# Design Review Update

## Parcel I - Residential

Reference: Parcel I (Residential) Design Review Update  
PB #179  
Cambridge Crossing  
Cambridge, Massachusetts

Reference: Parcel I (Residential) Design Review – View Glass  
PB #179  
Cambridge Crossing  
Cambridge, Massachusetts

# GFA COMPARISONS | LEVEL 01 (GRADE)

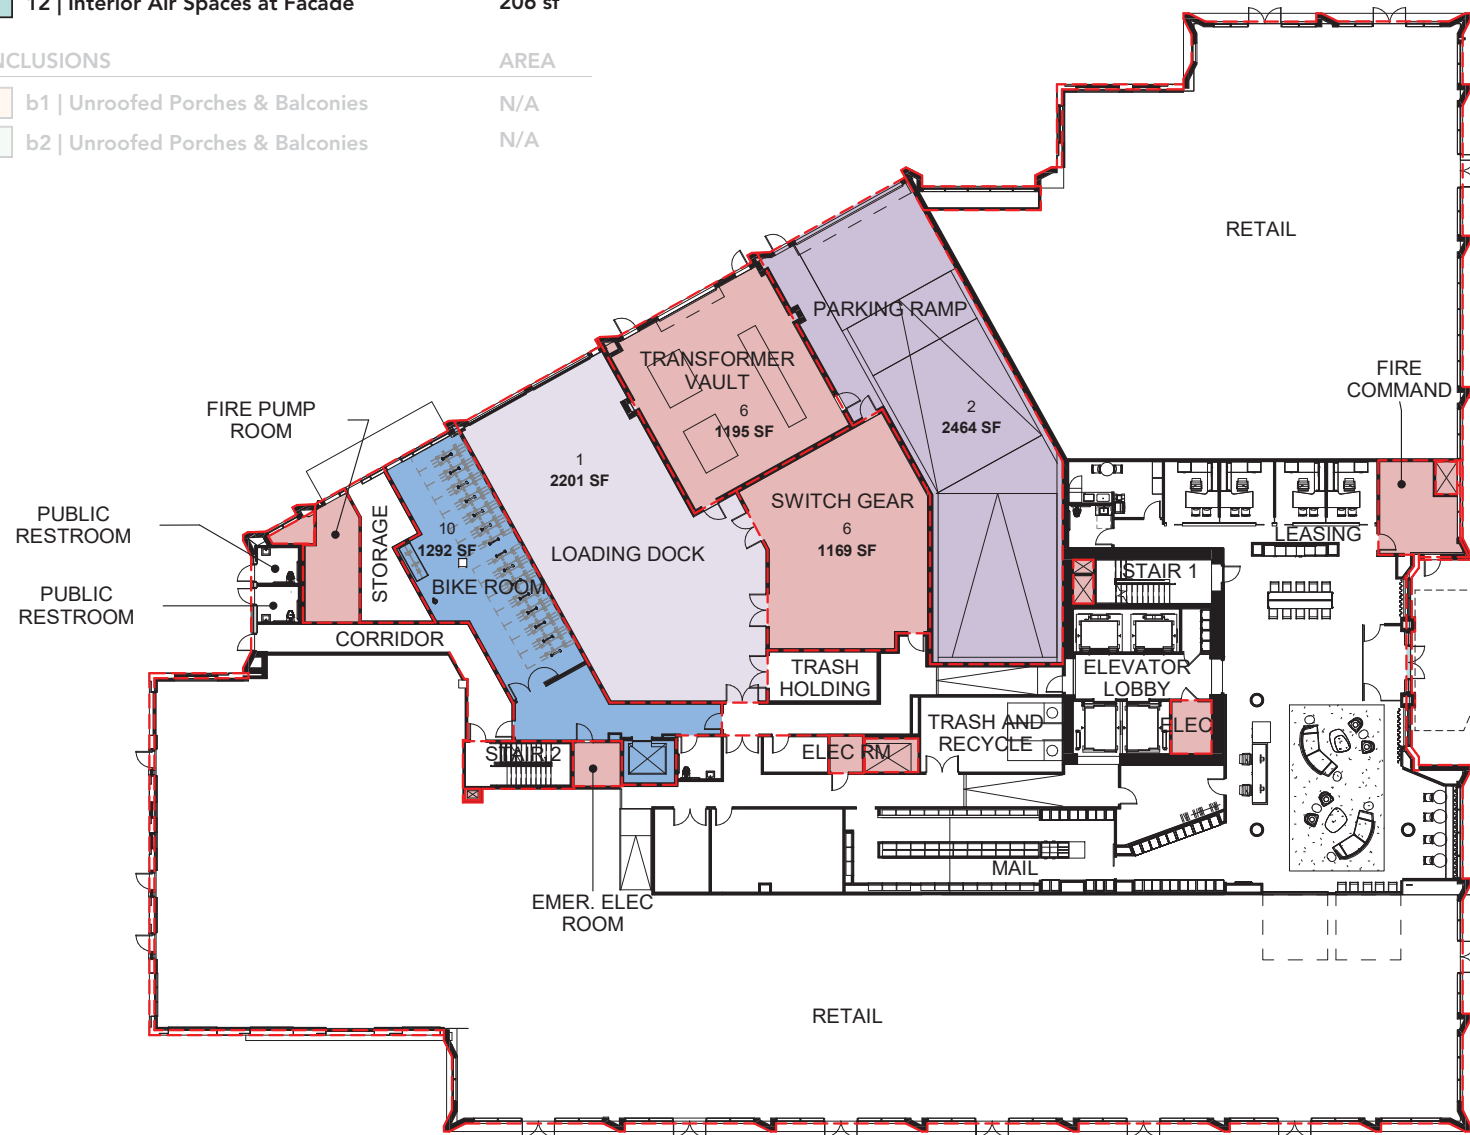
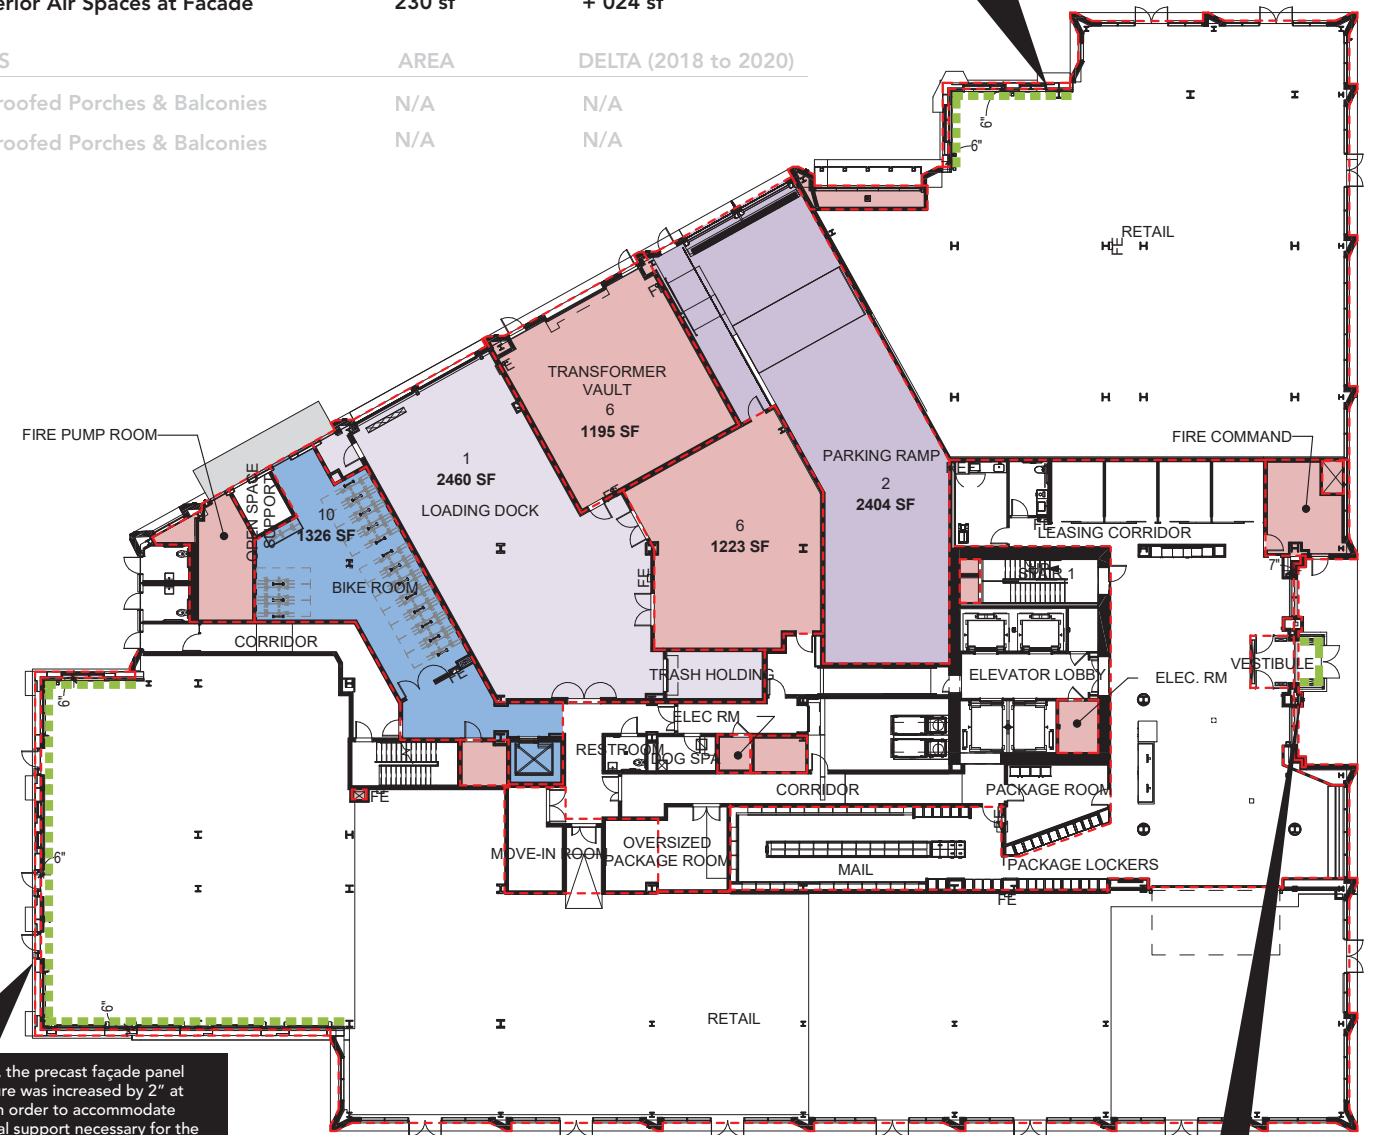
During coordination, the precast facade panel dimension to structure was increased by 2" at building perimeter in order to accommodate the upsized structural support necessary for the 11" deep precast panels. The 11" deep panels allow the 4" window recesses as approved by the Cambridge Planning Board.

Partial footprint of entry vestibule is proud of building facade

# GFA COMPARISONS | LEVEL 02 (BIKE STORAGE)

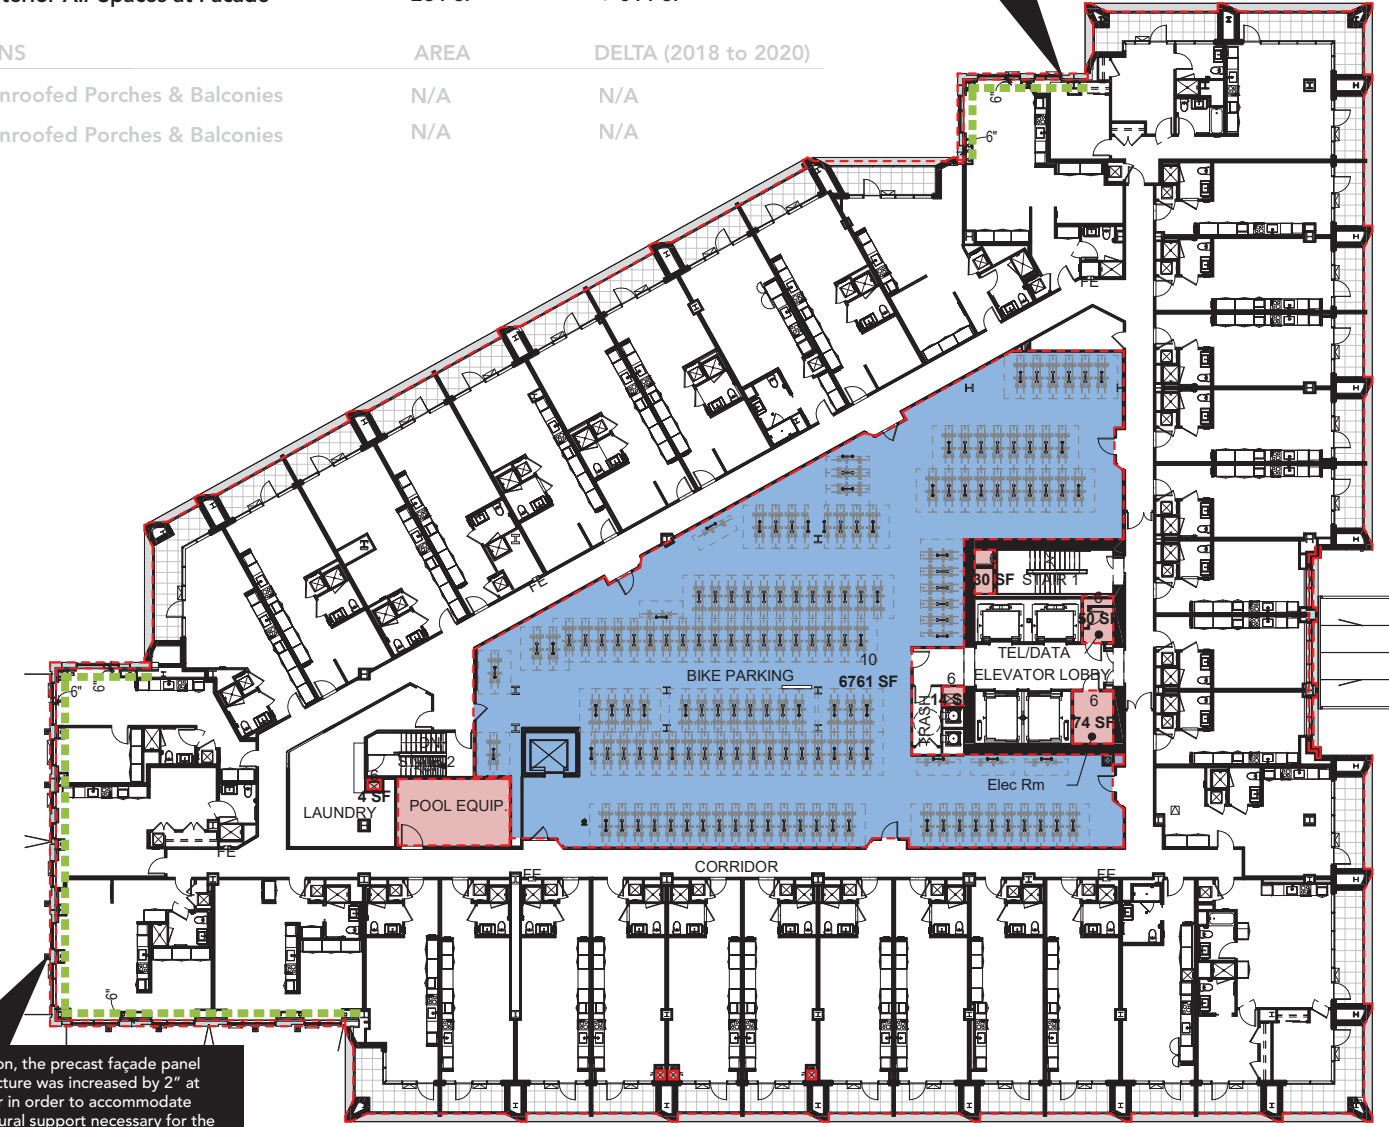
During coordination, the precast façade panel dimension to structure was increased by 2" at building perimeter in order to accommodate the upsized structural support necessary for the 11" deep precast panels. The 11" deep panels allow the 4" window recesses as approved by the Cambridge Planning Board.

# GFA COMPARISONS | LEVEL 03

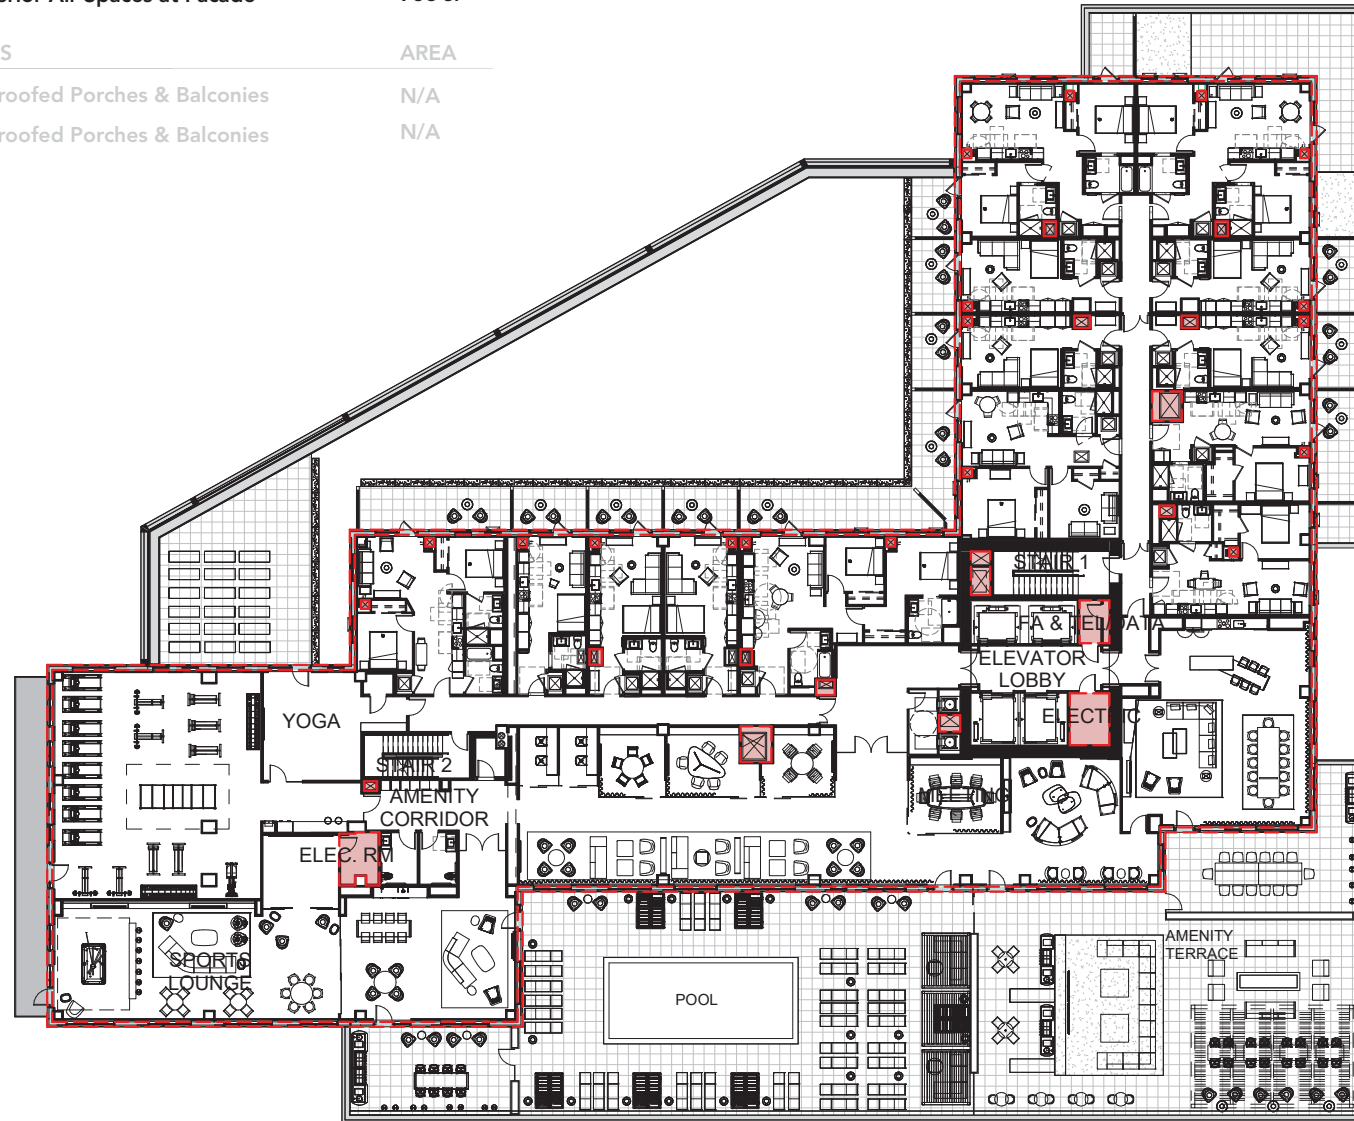
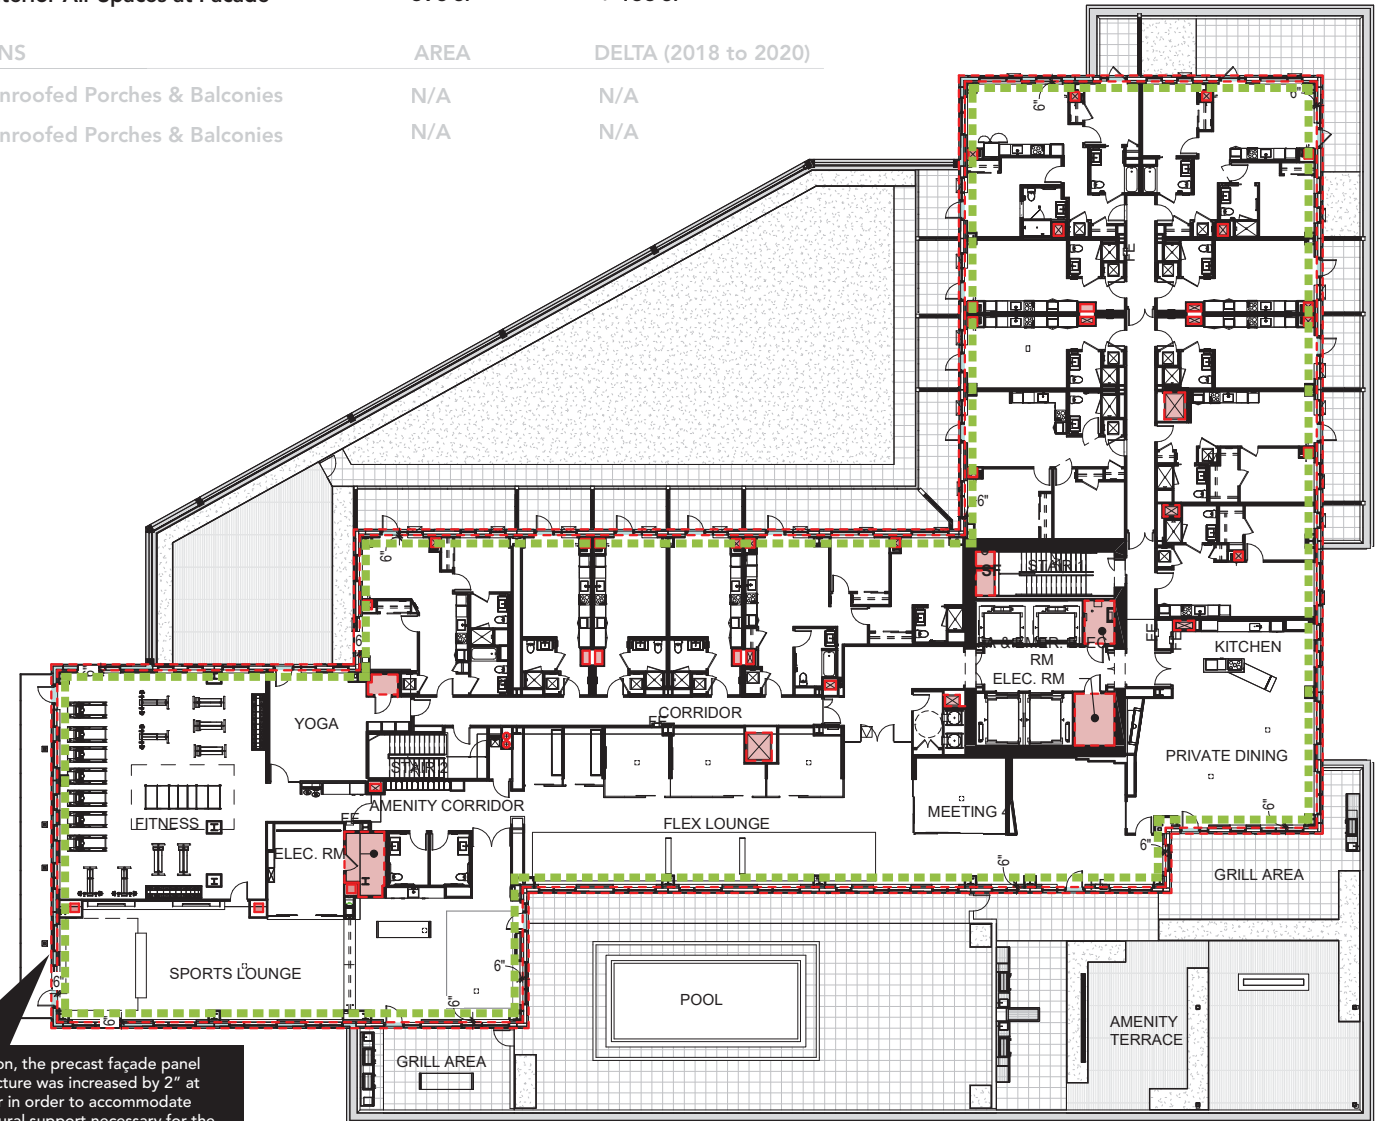
During coordination, the precast facade panel dimension to structure was increased by 2" at building perimeter in order to accommodate the upsized structural support necessary for the 11" deep precast panels. The 11" deep panels allow the 4" window recesses as approved by the Cambridge Planning Board.

# GFA COMPARISONS | LEVEL 11

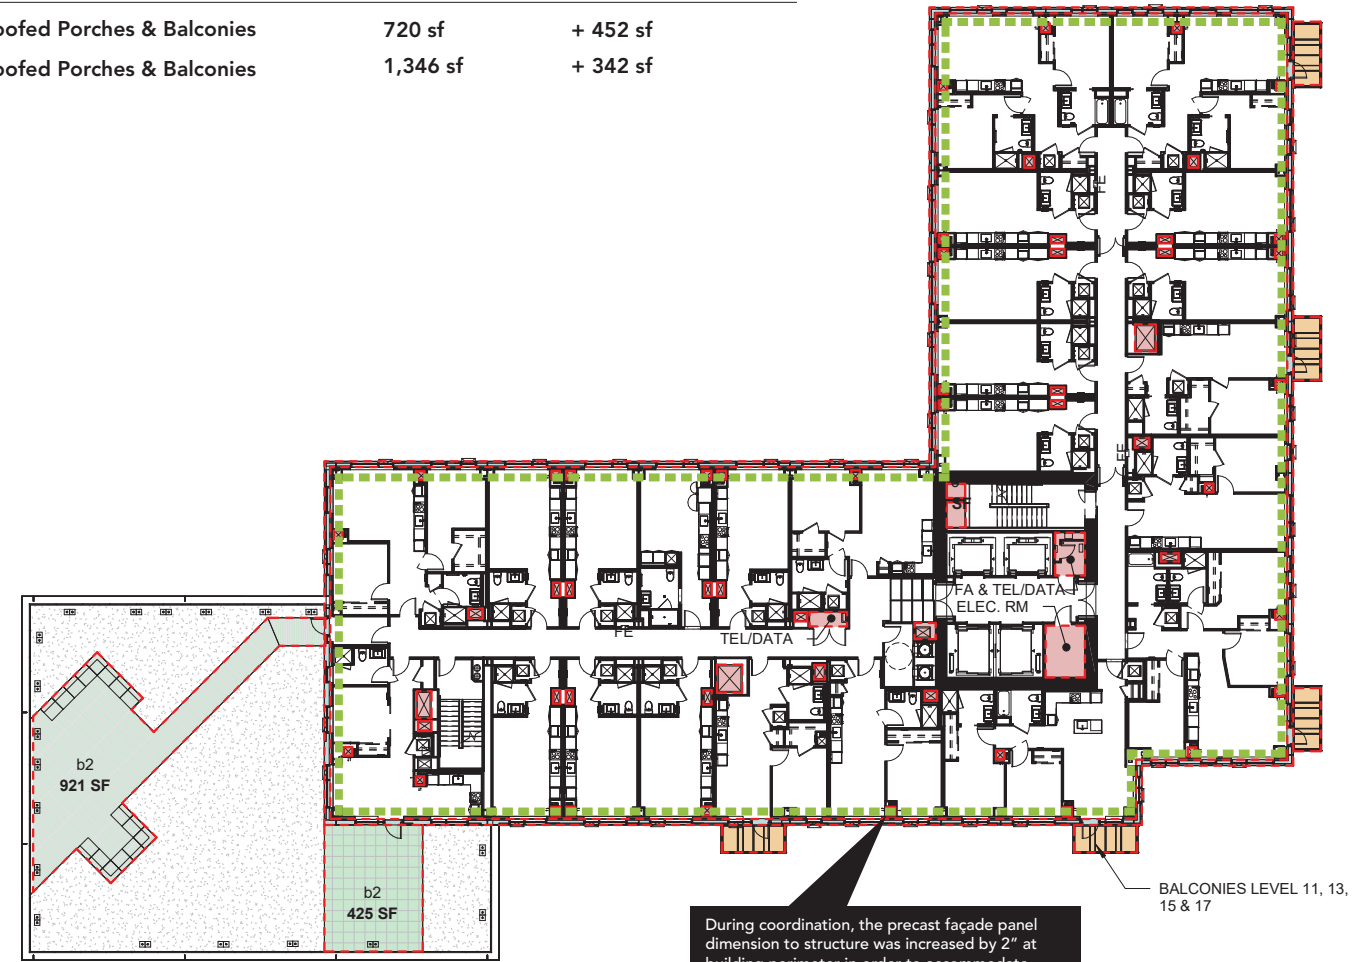
During coordination, the precast façade panel dimension to structure was increased by 2" at building perimeter in order to accommodate the upsized structural support necessary for the 11" deep precast panels. The 11" deep panels allow the 4" window recesses as approved by the Cambridge Planning Board.

# GFA COMPARISONS | LEVEL 12

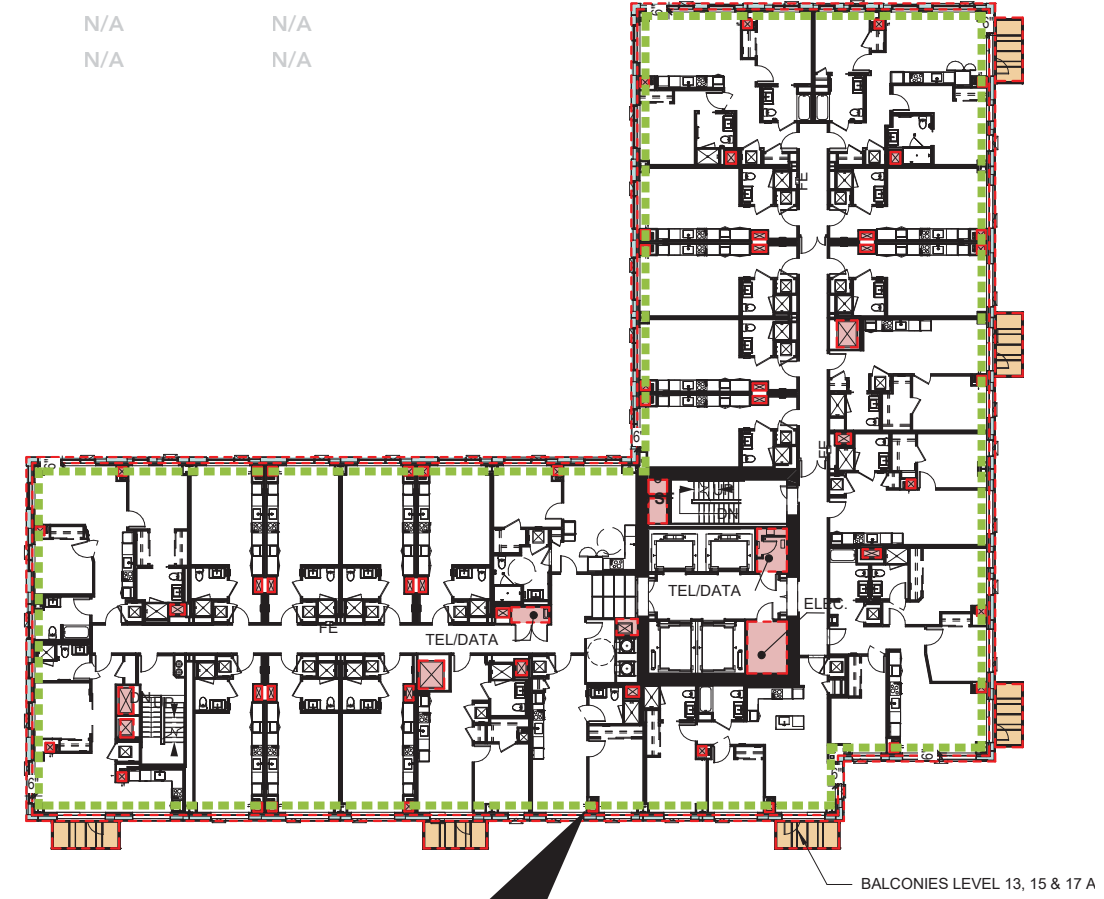
During coordination, the precast façade panel dimension to structure was increased by 2" at building perimeter in order to accommodate the upsized structural support necessary for the 11" deep precast panels. The 11" deep panels allow the 4" window recesses as approved by the Cambridge Planning Board.
